Re: LU 20-134213 AD

Site Address: SW Upper Hall Ave and SW 16th Street, Portland, Oregon

This is my response to the November 3, 2020, Notice of a Type II Proposal in Your Neighborhood.

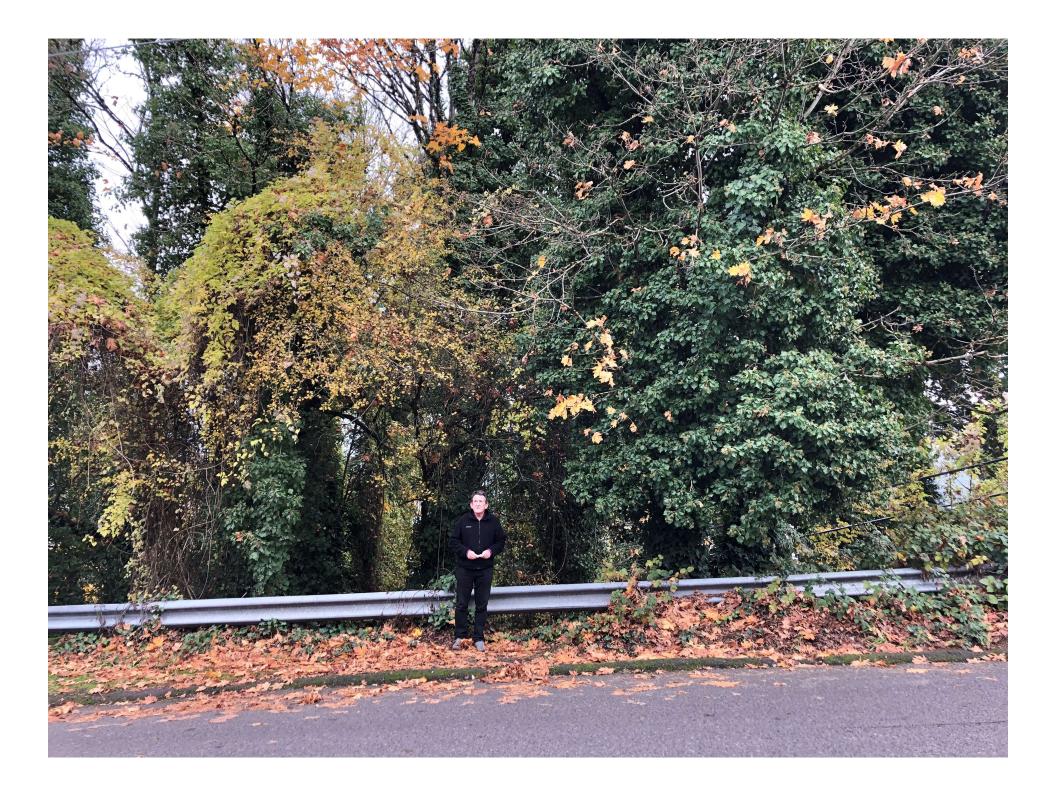
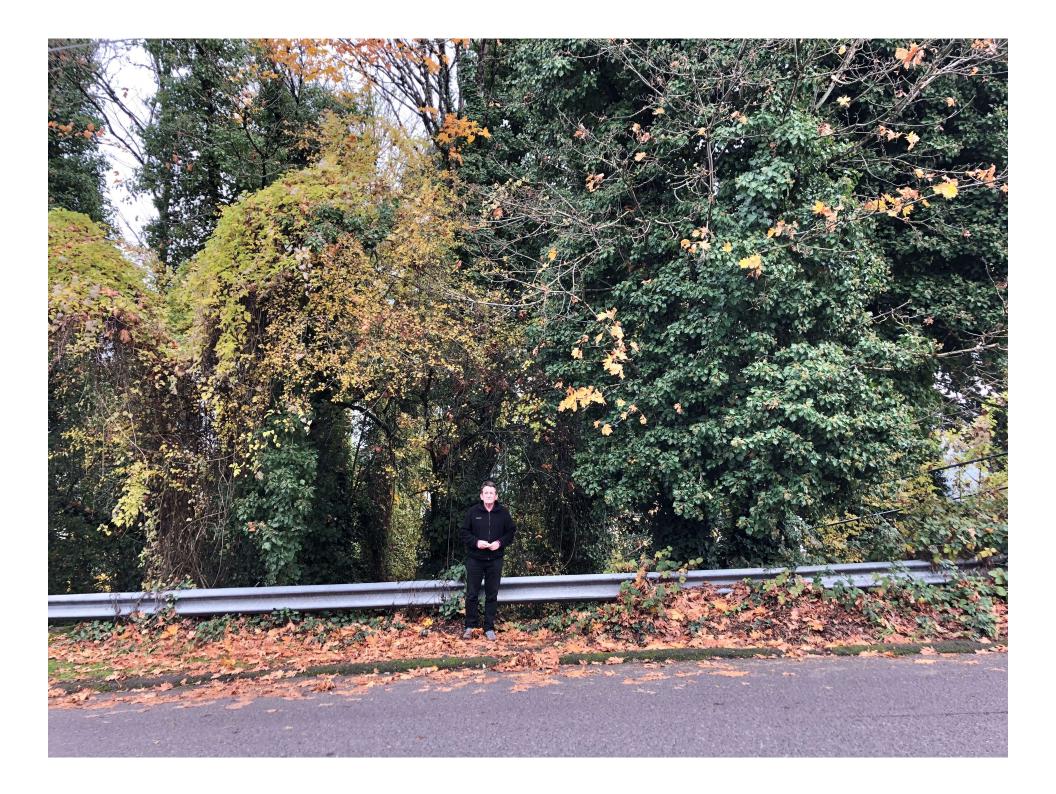
Mr. Gulizia- Attached are 12 photos of the two existing homes taken from Upper Hall Street elevation perspective and looking east. One is above and right next to the proposed 2-story structure and the other is below and located the second lot away from it. I am copying the two owners.

The other photos are at street level of the unbuilt lot so the City staff can see the 27-28' impact and the out of character and negative effect of the expanded height 4x the existing code allowance. A simple drive by the affected area reveals the actual harm to the appearance, nature and the livability of this unique hillside neighborhood.
